ADDENDUM 3
APRIL 2011

Specification for Rotary Drill Stem Elements

ANSI/API SPECIFICATION 7-1
FIRST EDITION, MARCH 2006

**ISO 10424-1:2004 (Modified), Petroleum and natural
gas industries—Rotary drilling equipment—Part 1:
Rotary drill stem elements**

Figure 12 — Measurement Definitions for Stabilizers

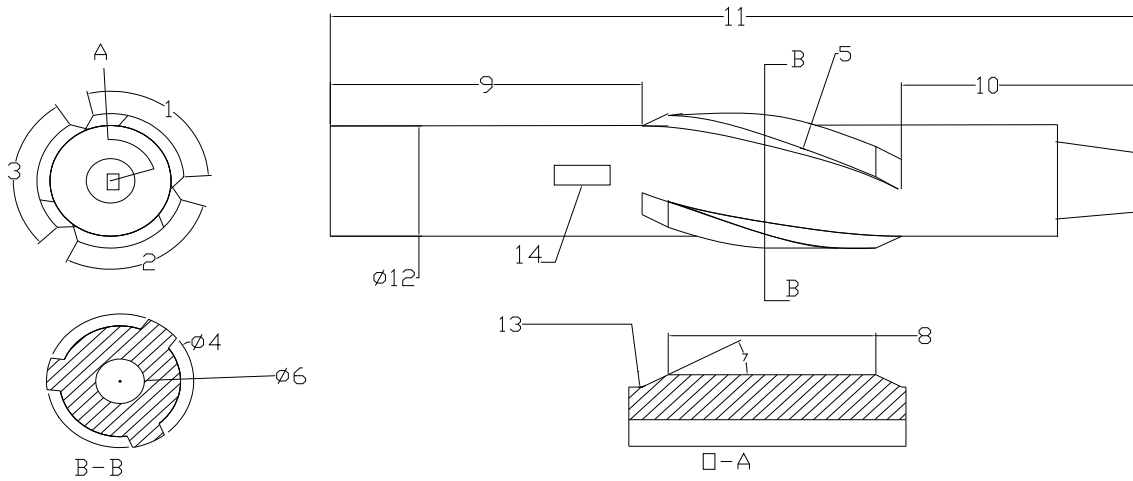
This Clause applies to String Stabilizers and Near-bit Stabilizers, with either Integral-Body or Welded-Blade construction. The important dimensions of stabilizers are defined in Figure 12.

Figure 13 — Sampling locations

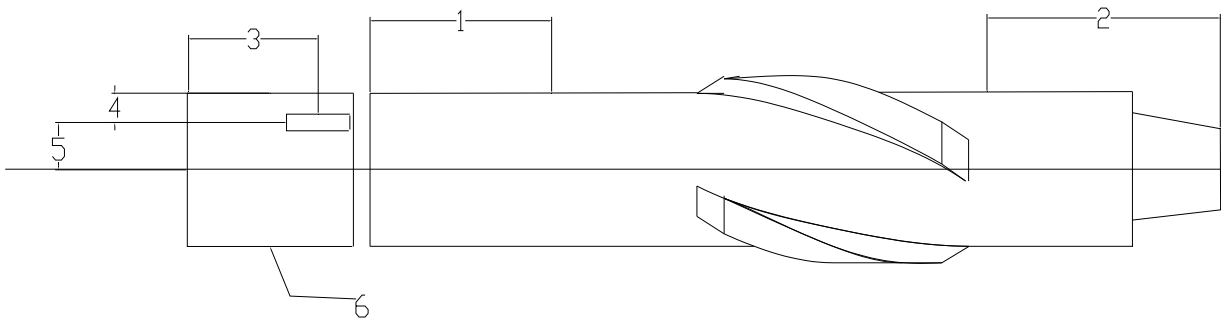
For an integral-blade stabilizer, the tensile and impact specimens shall be taken from a prolongation of either neck, with the center of the specimen at least 100 mm (4 in.) from a free end, and at least 25 mm (1 in.) below the finished surface of the neck as shown in Figure 13. The prolongation shall be the same diameter as the neck at the time of heat treatment. The uniform region shall extend for at least 400 mm (16 in.) from each end of the finished stabilizer, or to within 25 mm (1 in.) of the stabilizer blades, whichever is less, as shown in Figure 13. The extent of the area of controlled properties shall be verified by Brinell hardness testing, with a minimum hardness of 285 HBW.

When standard steel material is heat-treated as a forging or bar, without knowledge of the final neck diameter, the sampling location shall be determined by the largest diameter of the forging, or the diameter of the bar.

Figure 14 — Blade taper geometry

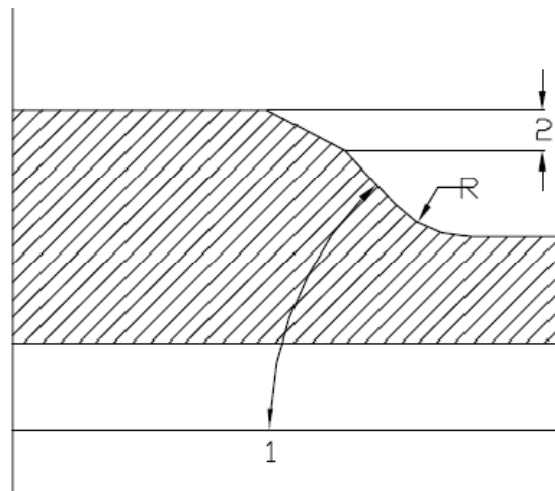
a The taper angle requirement applies only for the first 1 in. radially from the blade surface. If the blade height exceeds 1 in., the taper angle for the remainder of the height may be up to 45 degrees at the manufacturer's discretion. See Figure 14.

Figure 15 — Watermelon geometry**12.8 Customer information****12.8.1 Required information from customer**

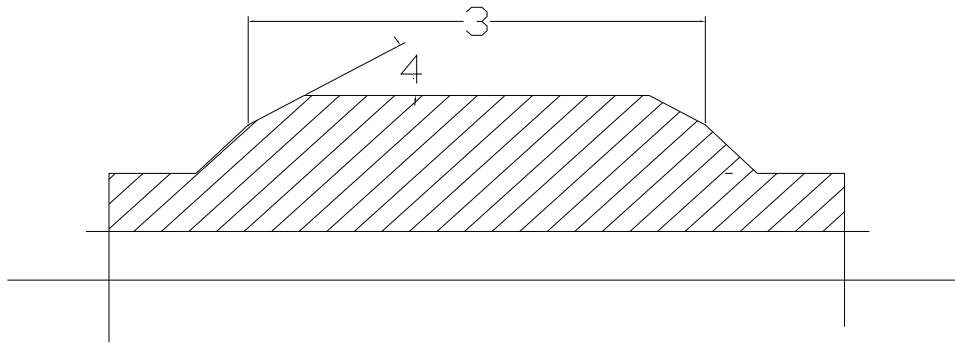
NOTE The crown also may be tapered at customer's option to form "watermelon geometry" as in Figure 4. The crown length includes the length of this shallow taper.

Figure C.1 — Correlation between significant dimensions of simple solid shapes of length "L" to the diameters of round bars

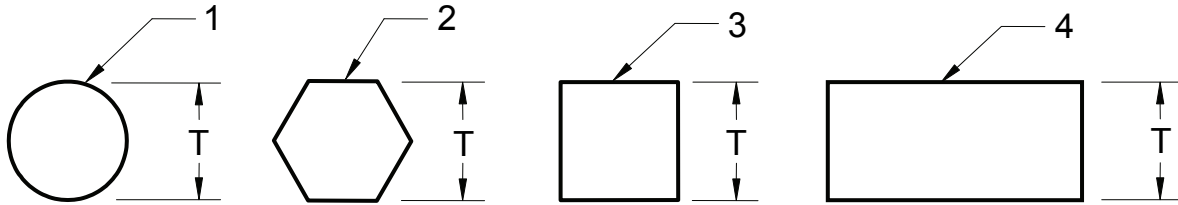
Most available data on heat treatment refers to round sections. If the production parts are not round at the critical location, the geometry at the critical location can be visualized as simple shapes such as squares, hexagons, plates or tubes that can be equated to an equivalent round (ER). The equivalent round has essentially the same cooling rate as the simple shape and the same response to heat treatment, so a QTC based on the ER of the critical location can be used to verify the mechanical properties.

Figure B.1 illustrates the basic models for determining the ER of simple solid shapes.

Figure C.2 — Correlation between the significant dimensions of simple hollow parts and hollow parts with more complicated shapes to the diameters of round bars

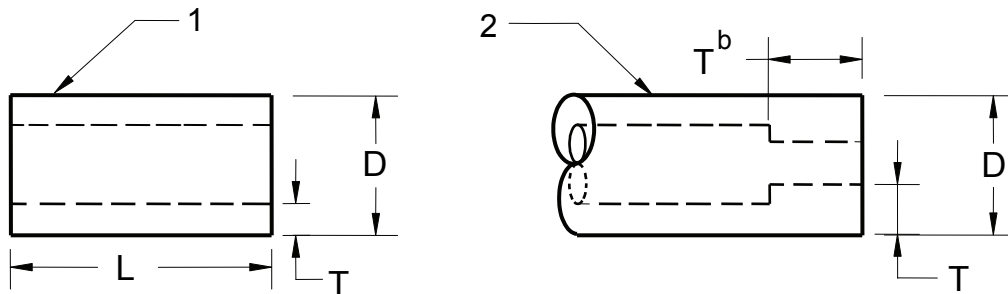
Figure C.2 illustrates the basic models for determining the ER of simple hollow parts and hollow parts with more complicated shapes.
